D206-642-151
Job Sheet 195711

Part Name: Replacement Skidtube, Low Gear with Run-on Landing Fits LH or RH

DRAWING NO. D3804	TITLE SKIDTUBE ASSEMBLIES, 206A/B	REV. A	DART AEROSPACE LTD ENGINEERING ORDER		D.E.O. NO. D3804-A-1	SHEET NO. SHEET 1 OF 1	SCALE NTS
DRAWN 12.10.12	CHECKED A.P.	DATE 12.10.22	MFG. APPR.	APPROVED	DATE 12.10.22	DE APPR.	
DATE 12.10.12	DATE 12.10.22	DATE 12.10.22	DATE 12.10.22	DATE 12.10.22	DATE 12.10.22	DATE 12.10.22	DATE 12.10.22

CHANGE C'BORED WELDED CROSSBOLT SPACERS TO SWAGED SPACERS

AMENDMENT TO DETAIL B
NOT TO SCALE

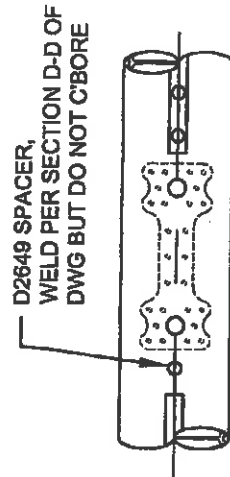
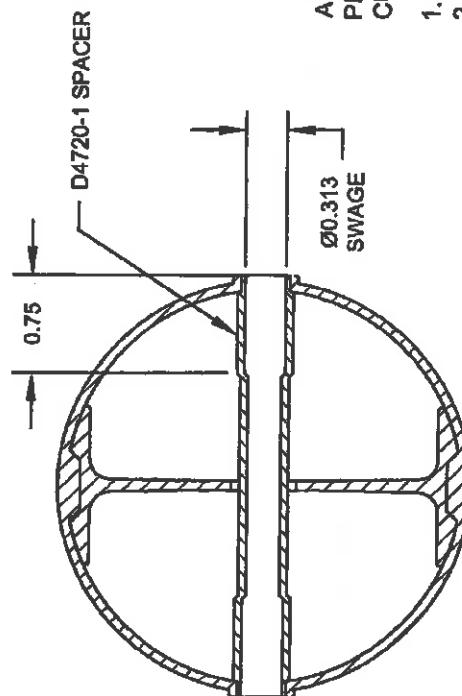
PARTS LIST IS AMENDED AS FOLLOWS:

ADD SECTION H-H BELOW, WHICH IS THE SAME SECTION VIEW AS SECTION D-D OF DWG. C'BORED HOLES ARE NOW SWAGED PER SECTION H-H BELOW, FOR THE Ø0.375 HOLE THAT IS NOT C'BORED, WELD PER SECTION D-D OF DWG (SEE AMENDED DETAIL B FOR REFERENCE).

QTY	QTY	PART NUMBER	DESCRIPTION
1	-043	1	D2649
18	19	D4720-1	CROSS BOLT SPACER

FOR Ø0.375 HOLES ONLY
FOR HOLES THAT ARE CURRENTLY C'BORED ONLY
NOT TO SCALE

AFTER DRILLING AND BENDING ASSEMBLY
PERFORM THE FOLLOWING FOR Ø0.375 HOLES THAT ARE
CURRENTLY C'BORED:

1. INSERT D4720-1 SPACER, 18 PL (-041) OR 19 PL (-043)
2. SWAGE TO Ø0.313 X 0.75 DP PER QSI 002
3. TRIM / GRIND FLUSH PER QSI 002
